A REPAIR

ON-SITE SEWAGE DISPOSAL SYSTEM HOWARD COUNTY HEALTH DEPARTMENT BUREAU OF ENVIRONMENTAL HEALTH

SUBDIVISION: Broadwater Estates LOT NUMBER: 2

ADDRESS: 5673 Chamblis Drive PROPERTY OWNER: _____

NOT TO SCALE

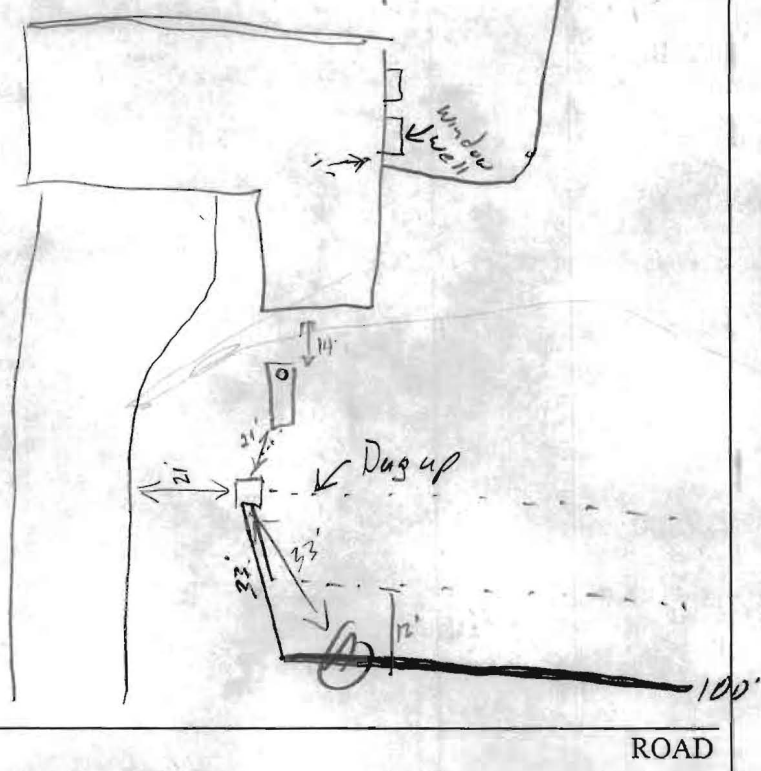
TRENCHES:	Trench to be 2' feet wide. Inlet <u>6'</u> feet below original grade. Bottom maximum depth <u>12'</u> feet below original grade. Effective area begins at <u>6'</u> feet below original grade. <u>6'</u> feet of stone below distribution pipe.
LOCATION:	<u>2' of fill on area at beginning of trench. Will be less further down trench. Keep bottom #</u>
PURPOSE:	In support of a building permit addition. Call for inspection when the ground is opened so sanitarian can recommend repair.

*invert level. Install/replace outlet baffle on S.T.
Use speed levelers in P.B.*

PRE-CONSTRUCTION 7/10/03 Dug up 1st trench. Trench was dry 1' down. Install (1) 100' trench to specs on 10/10/03

INSTALLATION 9/16/03 - Trench installed OK to cover 50
